Subject: Clifton Heights Storage Basin
Minor Project Modification
IOAP Project No. L_MU_MF_154_M_09B_B_A_8
DOJ Case No. 90-5-1-1-08254

MSD is requesting approval of a proposed minor project modification to the Clifton Heights Storage Basin project (IOAP Project No. L_MU_MF_154_M_09B_B_A_8). This request is a revision to the advanced notification provided in our letter dated September 20, 2012. This modification is part of an overall adaptive management review of the approved 2009 IOAP that will be documented in the proposed 2012 IOAP Modification to be formally submitted in 2014.

2014 Project Modification Request

Clifton Heights Storage Basin

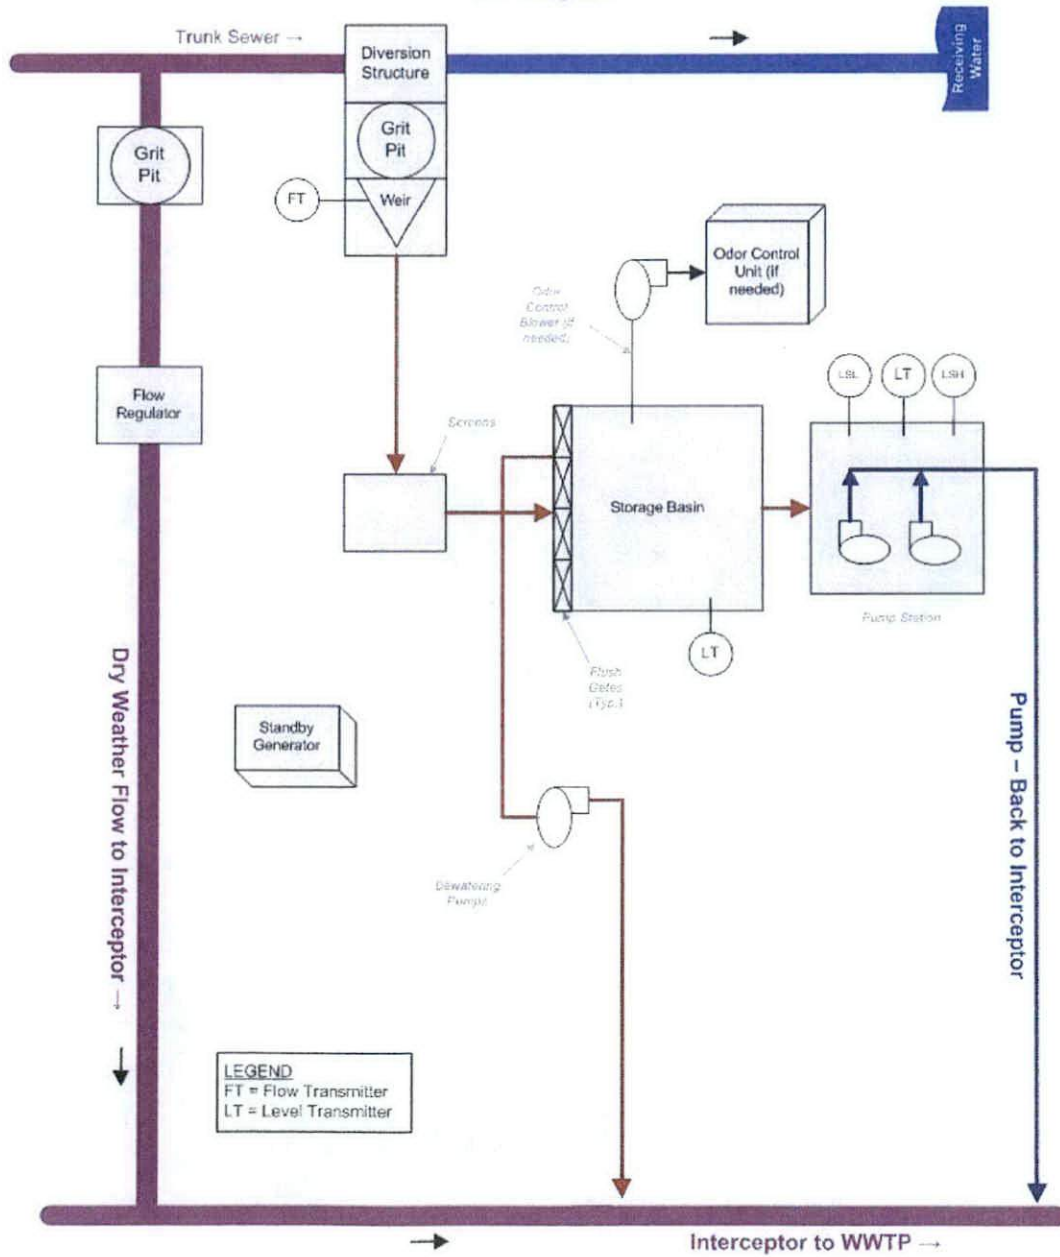
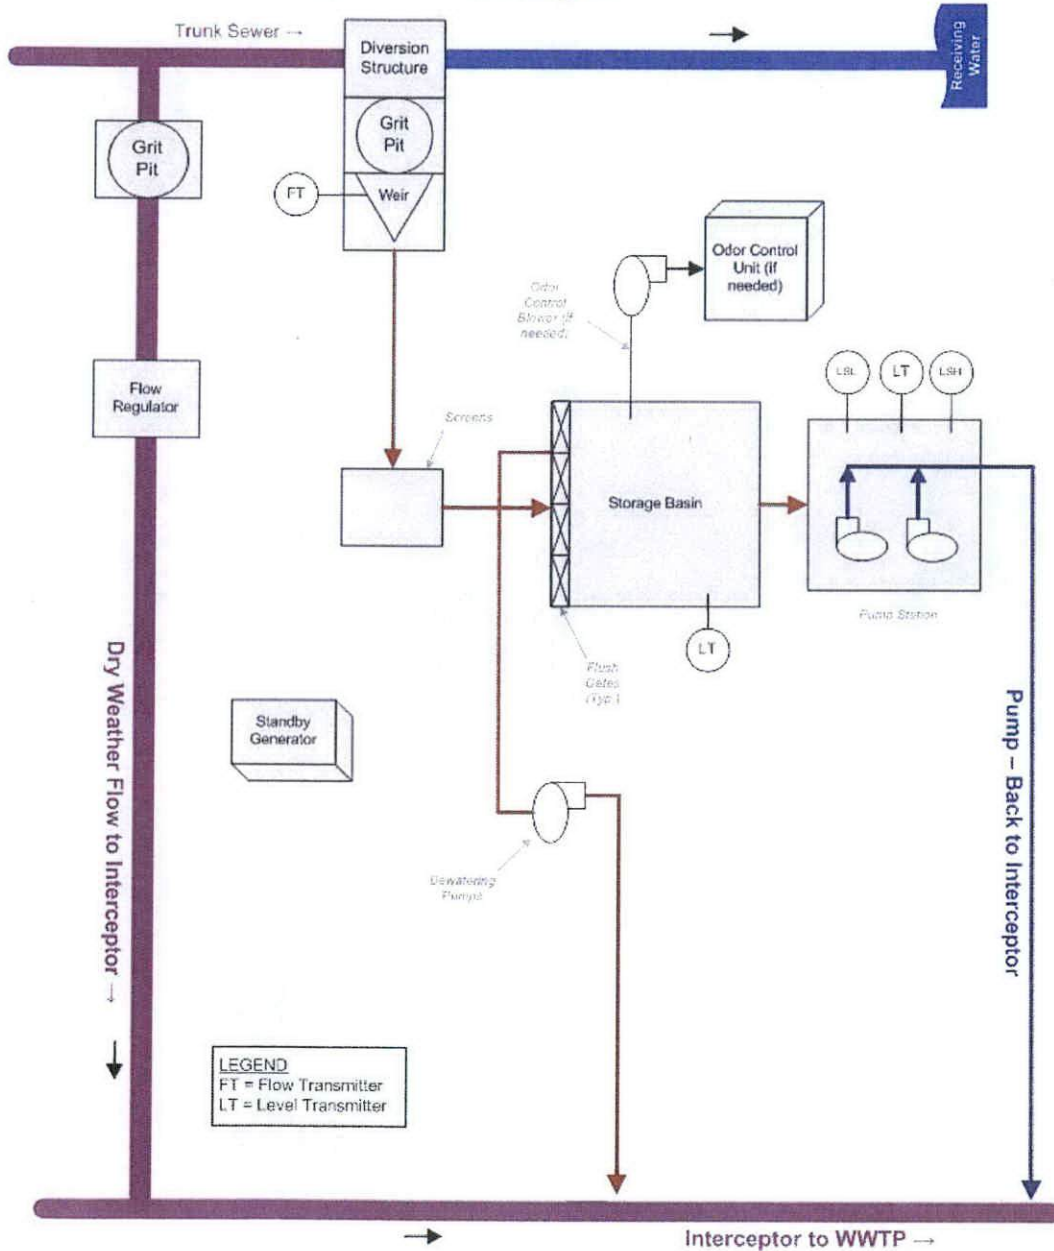
The project modification request is to change the basin size from 4.28 MG to 7.0 MG. No change is proposed in the level of control (4 overflows in a typical year) or schedule completion (December 31, 2018).

Based on the results of the re-calibration and basin redefinition, the hydrologic and hydraulic nodes showed that a basin size of 7.0 MG was required to meet the level of control of 4 overflows per year. Therefore, MSD proposes to change the Clifton Heights Storage Basin solution from a 4.28 MG basin to a 7.0 MG basin. These improvements will maintain the same completion date of December 31, 2018, as the original solution.

Project Description: This project includes a 7.0 MG storage basin and conveyance from each CSO to achieve 4 overflows in a typical year.
